CITY OF ALBUQUERQUE

Guardian Storage: Unser Blvd and Summer Ridge Rd

Re: Drainage Control Ordinance and NPDES CGP Violations for Erosion and Sediment Control – Guardian Storage

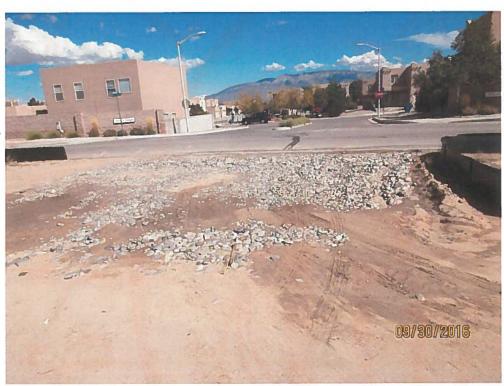
No change in condition of entrance. It is too narrow, does not have fabric underneath it, and it needs maintenance.

- 1. The stabilized entrance is to extend the entire width of the opening in the silt fence. (The entrance is very wide. It may be helpful to extend the silt fence on the north side to the south 10 feet or so.)
- 2. Fabric is to be placed underneath the rock. (See detail on approved ESC plan.)
- 3. The construction entrance is to be a continuous rock pad with no dirt area within it.
- 4. Pick up the trash and keep a clean site.
- 5. You are to obtain an approved Erosion and Sediment Control Permit.
